BLUE BIRD

Mislabeled Compressor Oil Type on A/C Data Plate

**Models Affected: 2009-11 Model Year Rear Engine Buses
With Feature 30006-13 Free Blow A/C or 30007-13 Ducted A/C**

S10SJ

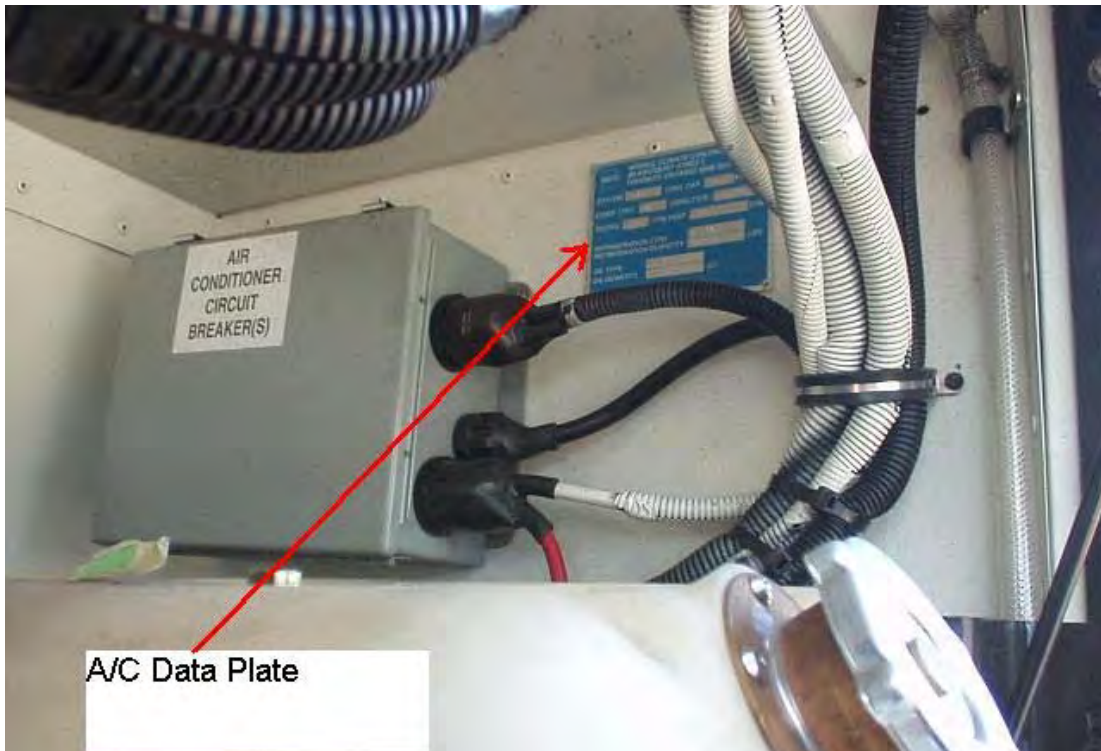
Air conditioner data plate on buses equipped with a Bitzer A/C compressor may have been stamped with incorrect compressor oil type.

Inspect A/C data plate to verify correct oil type specified for Bitzer A/C compressor. If plate specifies "POE" oil, unit can be returned to service. If data plate specifies "PAG" oil, a new data plate must be obtained with "POE" oil specified and installed.

1. Park the bus on a level surface, apply parking brakes, turn off engine and remove keys. Chock wheels.
2. Open engine compartment door and locate air conditioner data plate, see photo below.

3. Locate the “Oil Type” on the bottom of the data plate. If the oil type indicated is “POE”, the data plate is correct. If the oil type indicated is “PAG”, the data plate is incorrect and must be replaced with a new data plate that indicates “POE” oil type.
4. If “Oil Type” indicated is incorrect, complete the attached “S10SJ Replacement A/C Data Plate Request Sheet”. Body numbers are required in order to receive replacement A/C data plates.

5. After new data plate has been received, remove old data plate that had “PAG” oil listed and thoroughly clean surface area. Apply 2-sided tape to back of new data plate that has “POE” oil listed and affix to panel (see photon page 1) where original data plate was removed.
6. Remove wheel chocks and return unit to service.
